# 1959 - 1960 Corvette: Service Bulletin: Front and Rear Door Glass Loose in Run Channels

**Subject:** Front and Rear Door Glass Loose in Run Channels

**Bulletin No:** DR #651

**Date:** April 7, 1960

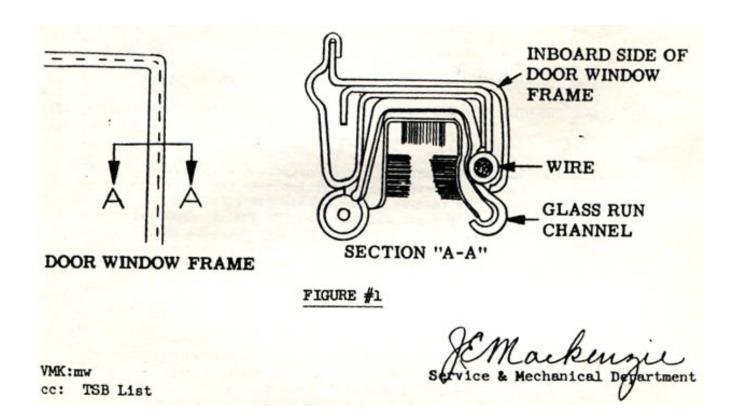
The condition of "in and out" looseness may be corrected by installing black insulated wire or similar material between the glass run channel and the inboard side of door window frame as shown in Section "A-A", figure #1. Wire should be approximately 15" long. Insert wire from belt line to top of window frame. Trim off excess wire as required.

The degree of "in and out" movement of the door window will determine the gauge of wire necessary to correct this discrepancy; however, a #14 gauge wire will normally correct the condition. On doors where the "in and out" movement of the window is very small, #20 gauge wire may be adequate.

If glass is still loose, a second piece of wire may be inserted between the channel and outboard side of window frame.

On front doors, the repair may be performed along the door lock pillar section only. However, on rear doors, the repair may be performed along either lock pillar or hinge pillar sections, or both, depending upon severity of condition.
